Subject: MHI's Response to US-APWR DCD RAI No.584-4468 Revision 0

References: 1) "Request for Additional Information No. 584-4468 Revision 0, SRP Section: 09.02.02 – Reactor Auxiliary Cooling Water Systems Application Section: 9.2.7 Chilled Water System" dated May 10, 2010.

Responses to Request for Additional Information No. 584-4468, Revision 0

US-APWR Design Certification Mitsubishi Heavy Industries Docket No. 52-021

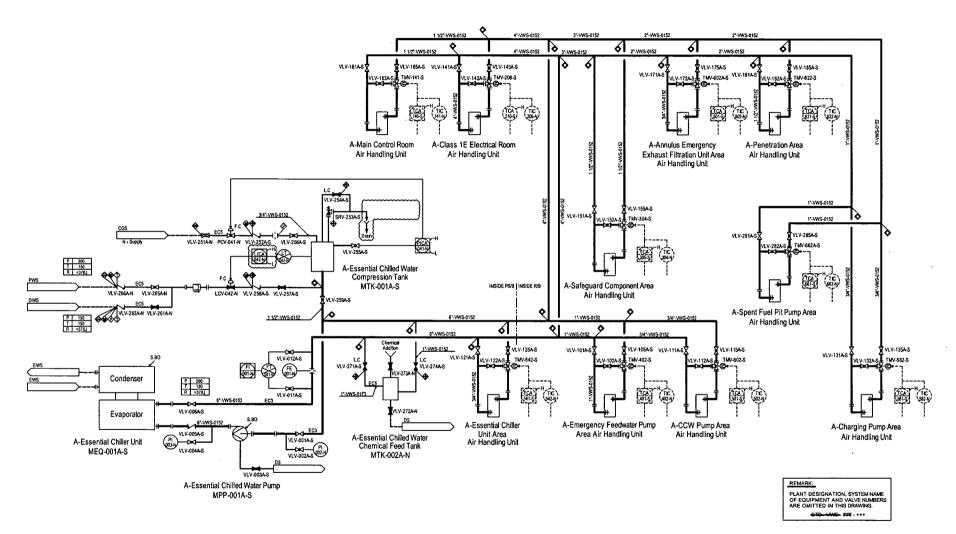
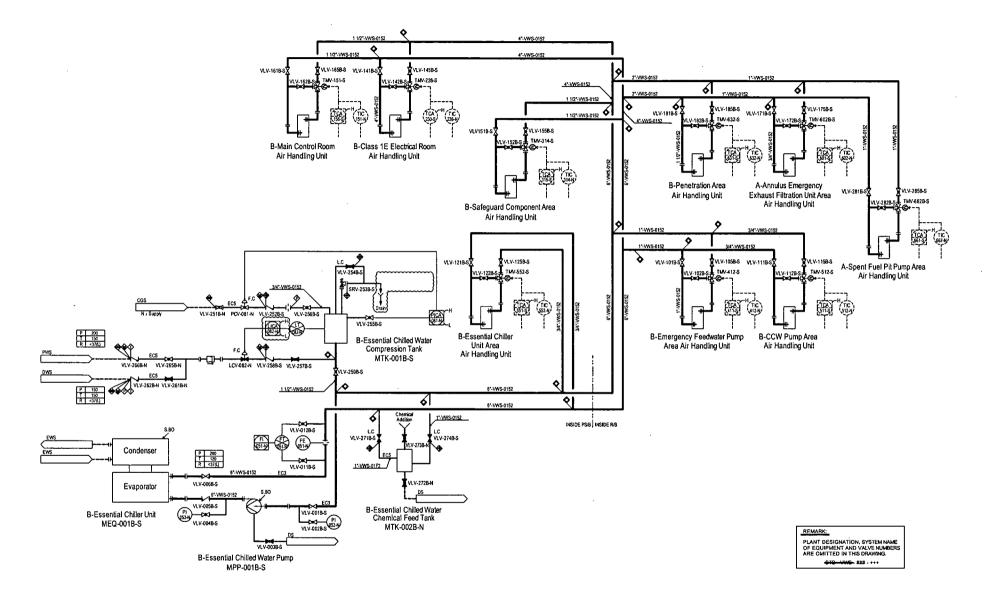
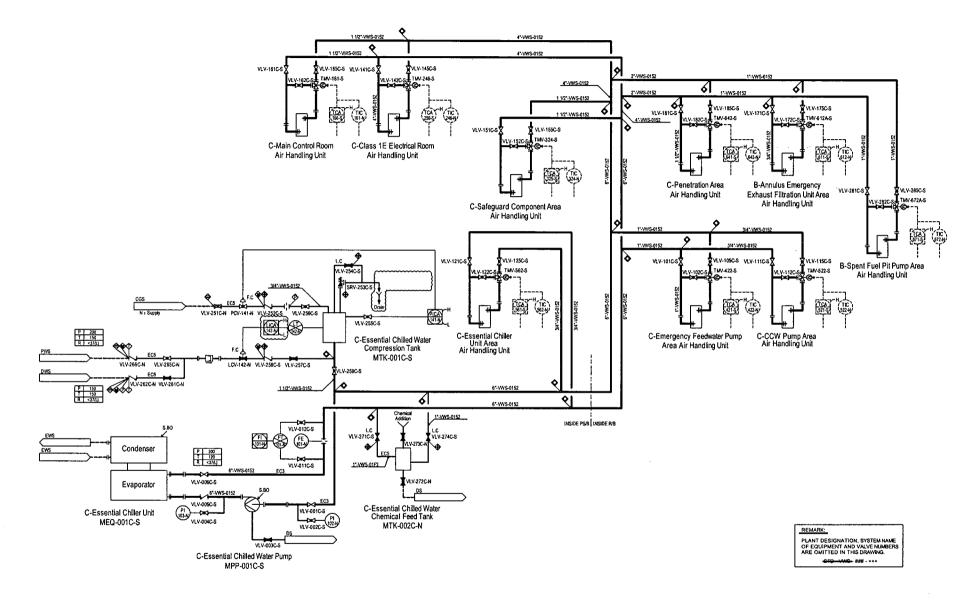
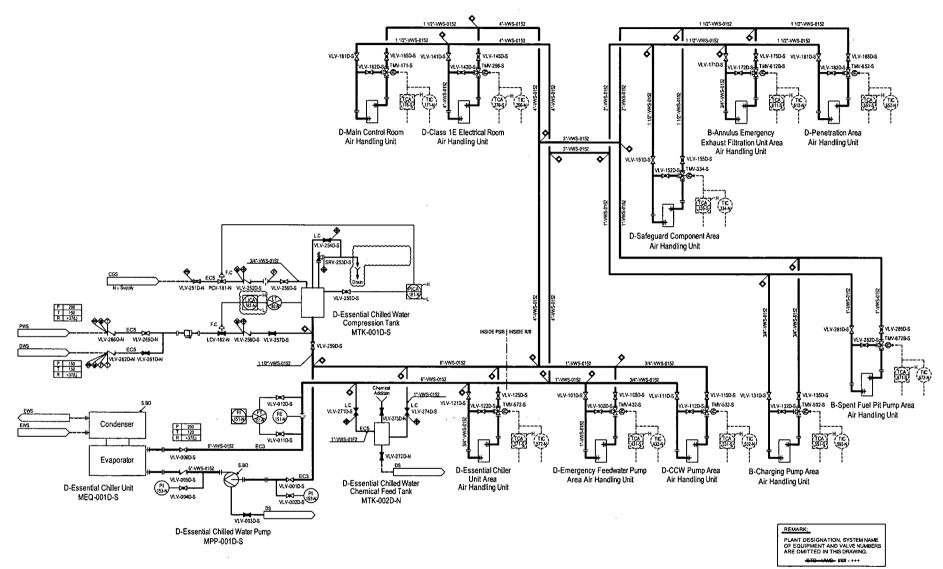
2. The applicant added new ITAAC #13 to address ECWS pump and compression tank testing. The staff reviewed the response and found that it was not sufficient. First, the ITAAC should verify the sizing of the compression tank (including the 7-day makeup water supply), not just the ECWS pump performance at minimum tank level. Second, while the nitrogen make-up and relief valve on the compression tank may be non-safety, an ITAAC is needed for where the nitrogen is relieved so that the staff can confirm that it will not pose a hazard for occupancy. Finally, the ITAAC for ECWS pump NPSH only accounts for minimum compression tank level. The ITAAC should also account for minimum tank pressure and temperature limitations.

The applicant added new ITAAC #13 to address ECWS pump and compression tank testing. The staff reviewed the response and found that it was not sufficient. First, the ITAAC should verify the sizing of the compression tank (including the 7-day makeup water supply), not just the ECWS pump performance at minimum tank level. Second, while the nitrogen make-up and relief valve on the compression tank may be non-safety, an ITAAC is needed for where the nitrogen is relieved so that the staff can confirm that it will not pose a hazard for occupancy. Finally, the ITAAC for ECWS pump NPSH only accounts for minimum compression tank level. The ITAAC should also account for minimum tank pressure and temperature limitations.

For question 5 [from RAI 343-2208, Question 09.02.02-13 response], explain why all instrumentation described in Section 9.2.7.5 are not found on Figure 9.2.7-1 and 9.2.7-2. In addition, indicate whether expansion tank level alarm should be included in Section 9.2.7.5.

The compression tanks are located in the PS/B in an open area that is subject to continuous ventilation air flow. Nitrogen relief from the compression tank would not create a hazard to occupancy of the PS/B due to the small relief volume in comparison to the space volume, and in consideration of the ventilation air flow. On this basis, no ITAAC is required related to compression tank nitrogen pressure relief. Note that this answer amends the response to RAI No.343-2208, Question No.09.02.02-6, in that the compression tank relief valve discharge line routing will be changed to be open-ended at the local floor drain in the PS/B.

MHI will revise Figure 9.2.7-1 and 9.2.7-2 to indicate that the ECWS compression tank relief valve discharge is routed to a local floor drain. See attached mark-up for changes.

MHI will revise Tier 2, DCD Section 9.2.7.5.1 to include ECWS compression tank level indication and alarm in the list of MCR instrumentation. The Compression tank level indication symbols in Figure 9.2.7-1 and 9.2.7-2 will be revised to be consistent with following change:

Figure 9.2.7-2 Non-Essential Chilled Water System Flow Diagram (1 of 3)

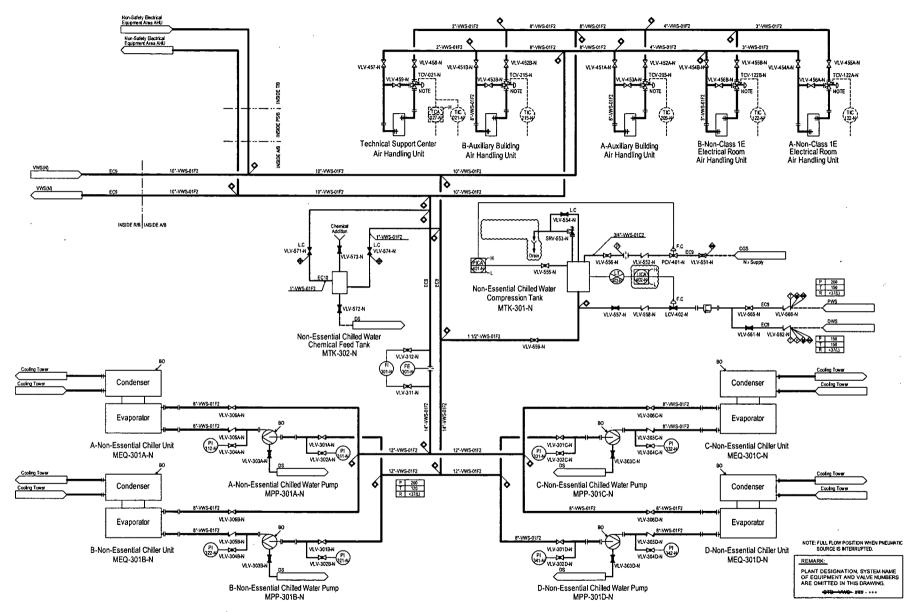
4. Tier 2 Table 3.2-2 (page 55 of 57) references "Valves VWS-MOV-425, -426" as Seismic Category I. However, Valve "-426" is not shown on non-ECWS Figure 9.2.7-2.

The non-ECWS valves that isolate the system from the CCWS are VWS-MOV-424 and -425 and these valves are seismic category I. DCD Table 3.2-2, first line item on Sheet 55 of 57, will be changed to read "Valves VWS-MOV-424, 425."
